# Product Change Notification

June 2007

### Bourns® Trimpot® Product Line Announces TC33 Product Change

Figure 1: Current versus New TC33

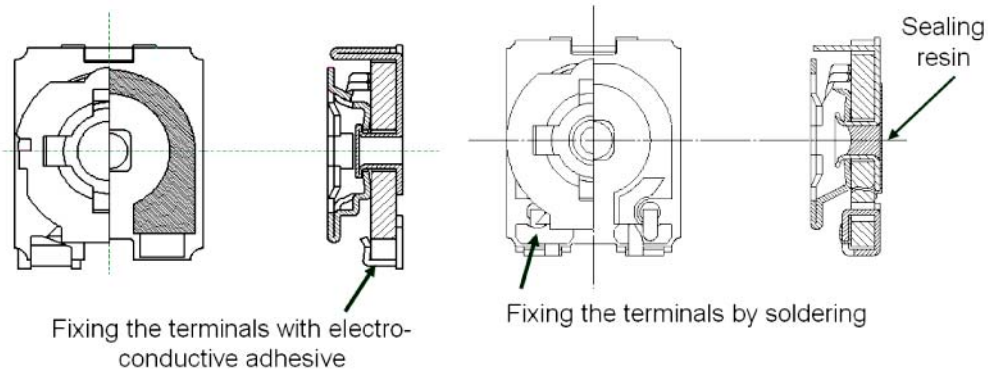
Bourns is pleased to announce a product improvement on [Model TC33](#). The current TC33 joins the terminals to the ceramic with an electro-conductive adhesive. The new version will solder the terminals in place. Another improvement is the addition of a sealing resin on the bottom of the trimmer. The sealing resin will add support to the rotor.

The new version will begin shipping on September 3, 2007. There will be a transition period where both versions will be shipped.
